## **HAIFA ESTATES SUBDIVISION**

Engineering Comments: **FINAL PLAT COMMENTS** (should be addressed prior to submitting the FINAL PLAT for review and/or signature by the City Engineer):

APPLICATION NUMBER 4 DATE August 19, 2021

# DETAIL SITE PLAN

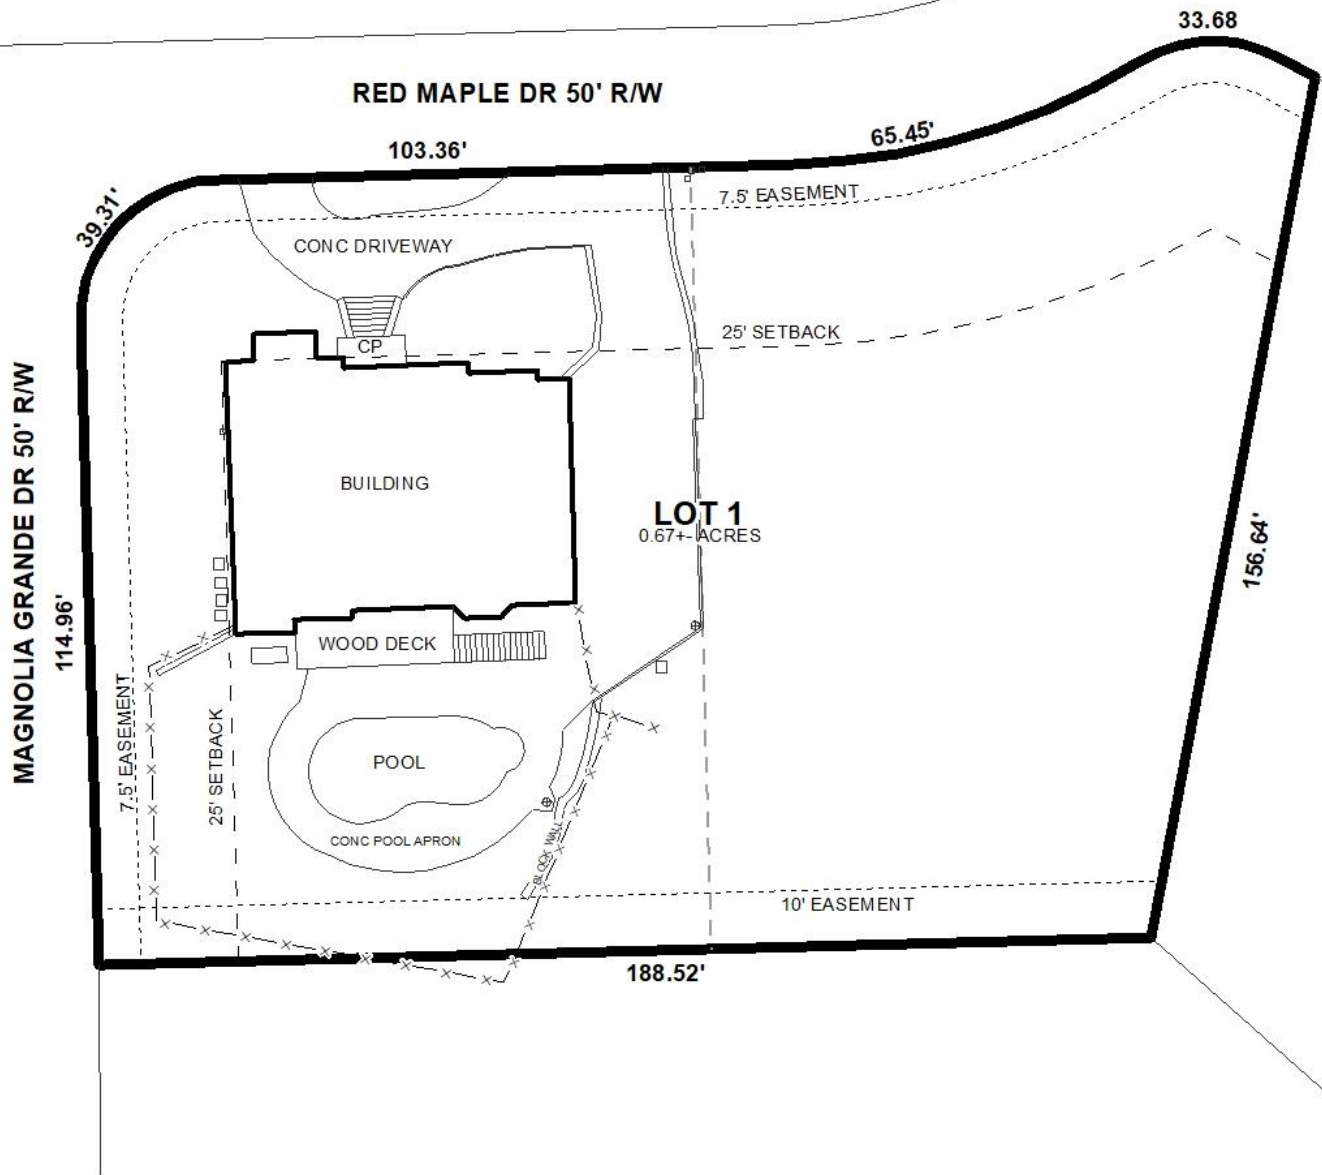
The site has frontage on Red Maple Drive and Magnolia Grande Drive, both minor streets with curb and gutter and compliant 50-foot rights-of-way, and a compliant 25-foot radius curve at the intersection; therefore, no dedication would be required. As on the preliminary plat, the right-of-way widths of both streets should be retained on the Final Plat, if approved. As on the preliminary plat, the 25-foot minimum building setback line should be retained on the Final Plat. The proposed lot meets the minimum size requirements of the Subdivision Regulations. As on the preliminary plat, the lot size label in both square feet and acres should be retained on the Final Plat, or a table should be furnished on the Final Plat providing the same information.

The preliminary plat indicates a ten-foot drainage easement along the South boundary of the proposed lot, as well as a 7.5-foot drainage and utility easement along both street frontages. Therefore, a note should be required on the Final Plat stating that no structure may be placed or constructed within any easement without the permission of the easement holder.

As per the Traffic Engineering comments, the driveway number, size, location, and design are to be approved by Traffic Engineering and conform to AASHTO standards. A note should be required on the Final Plat stating these comments.

- 1) retention of the right-of-way widths of both streets on the Final Plat;
- 2) retention of the 25' minimum building setback line along both street frontages on the Final Plat;

- 3) retention of the lot size label in both square feet and acres on the Final Plat, or the furnishing of a table on the Final Plat providing the same information;

- 4) placement of a note on the Final Plat stating that no structure may be placed or constructed within any easement without the permission of the easement holder;

- 6) placement of a note on the Final Plat stating the Traffic Engineering comments: (Driveway number, size, location, and design to be approved by Traffic Engineering and conform to AASHTO standards.);
